NMOCD-REC'D: 09/01/2020 Form C-103
June 19, 2008

Well: OXY Mako State Com #1
 Location: 1370 FSL and 1650 FEL
 Sec 5 T-19-S R-29-E
 Eddy County, New Mexico
 API# 30-015-29337

EXISTING WELLBORE SCHEMATIC

WELLBORE SCHEMATIC AFTER PLUG AND ABANDONMENT

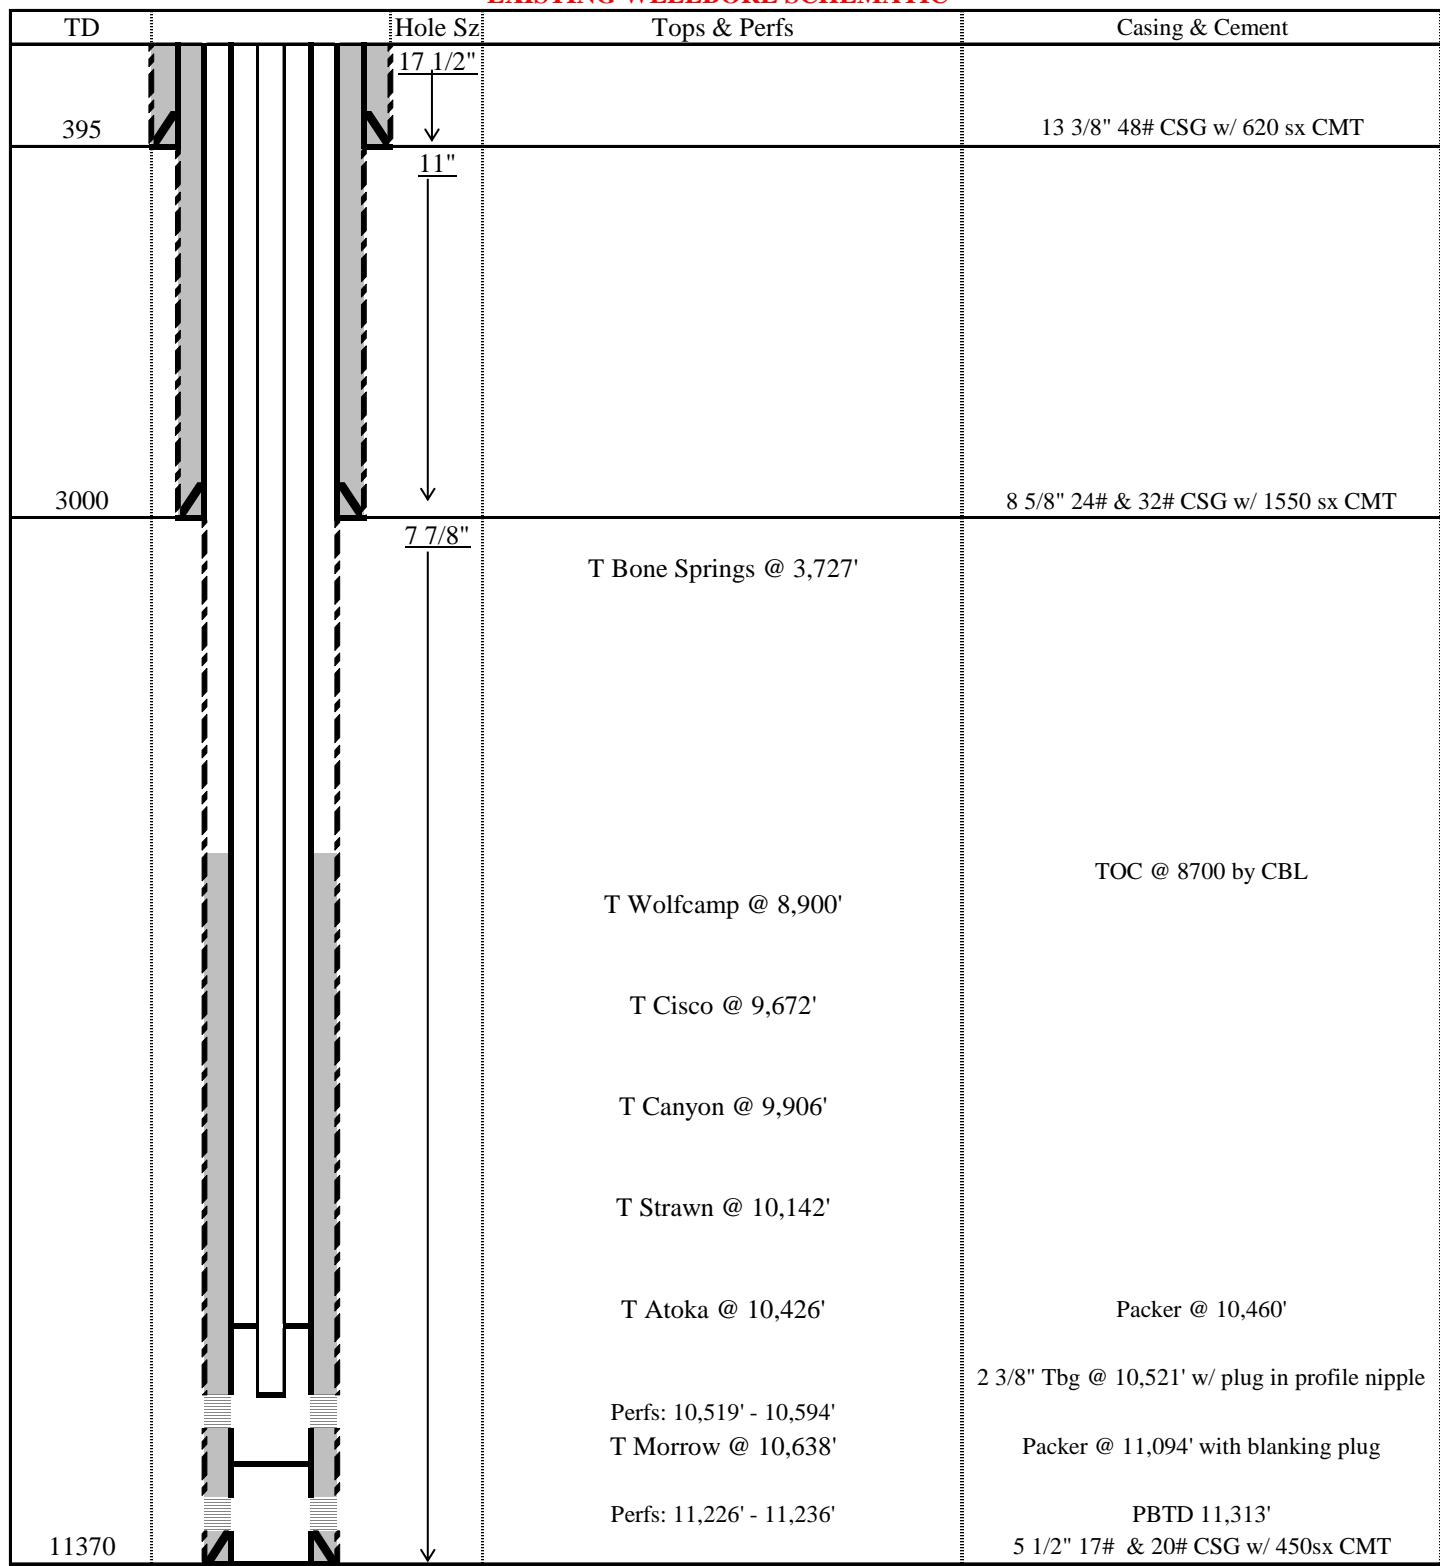
DB 35' of class H cmt on PKR @ 11094' - WOC & tag

51/2" CIBP w/ cl H cmt

5 1/2" csg

8725'

Perf @ 445' and attempt to sqz cmt to surf

****SEE ATTACHED COA's****

MUST BE PLUGGED BY 9/3/2021
